COMPUGRAPHIC CORPORATION

EN0302
SHEET 1 OF 5

Run Full indication
WIRE SERVICE RACK CONNECTIONS

SHEET 2 OF 5

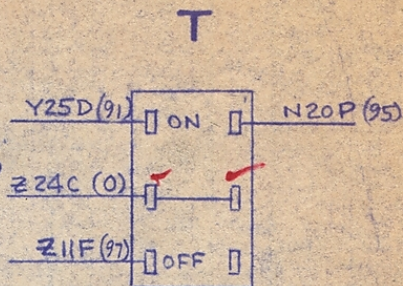
CONNECT THE FOLLOWING COLORS TO TERMINALS SHOWN. THESE WIRES ARE IN WIRE SERVICE CABLE.

TO POWER SUPPLY #2

- #18 WIRE
- PIN B (9) -12V
 - PIN C (2) + 6V
 - PIN A (0) ± 0V

ADD POWER TO N25 A, B, C
